Butterfly Connections

Title Butterfly MP3 Nick Lott		
Size A4	Number	Revision C
Date: 1/05/2005	Sheet of	
File: E:\My Documents\...MP3Butterfly4.SCH	Drawn By:

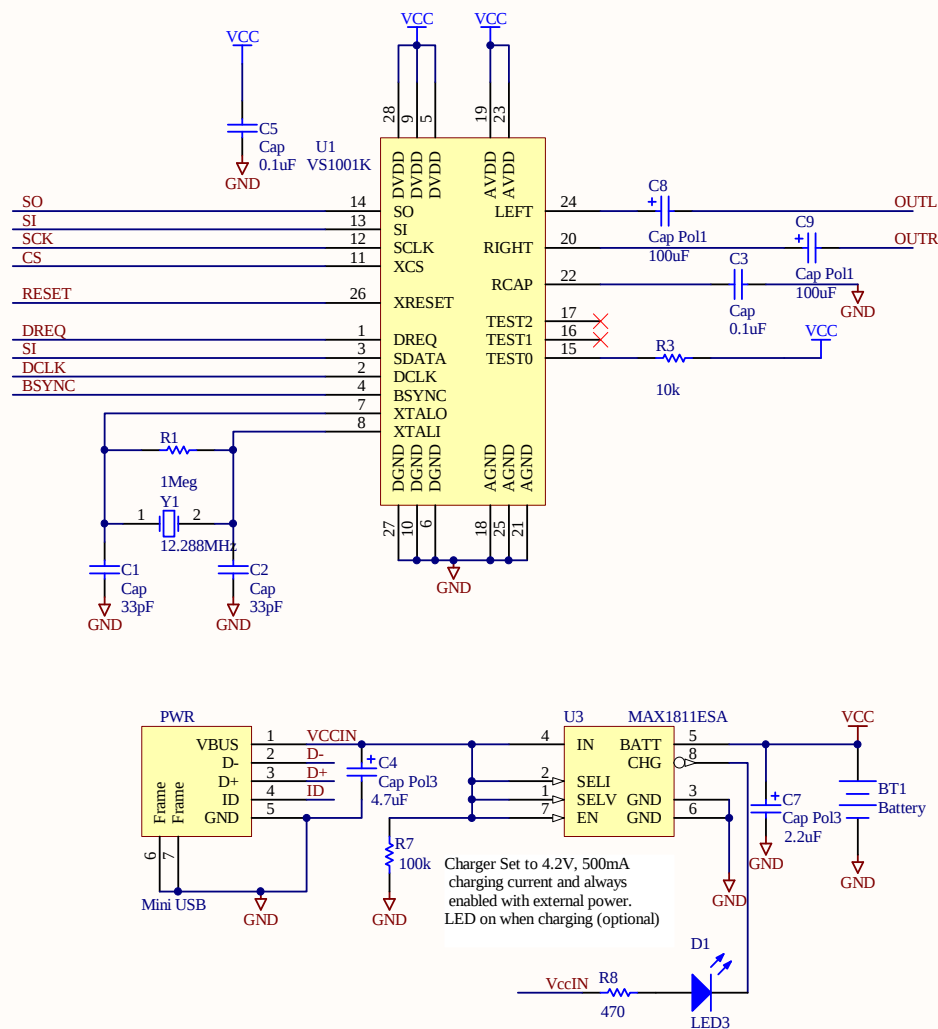
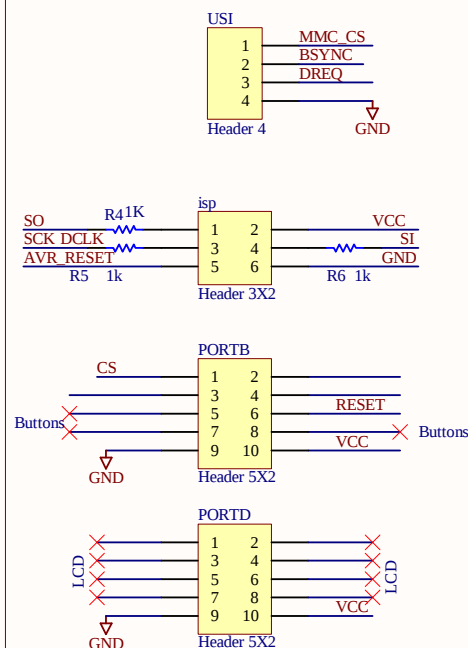
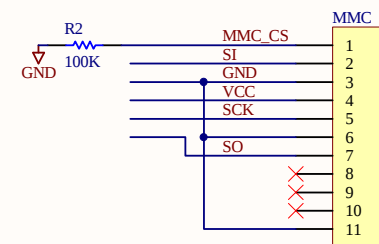
- Rev B
- Added pulldown resistor on MMC_CS pin
- removed separate AVCC and VCC.
- Added Diode pwr protection
- output of regulator now used to power butterfly

- Rev C
- Added MAX1811 and LED to charge LiION/polymer batteries
- Changed Pwr In to USB socket
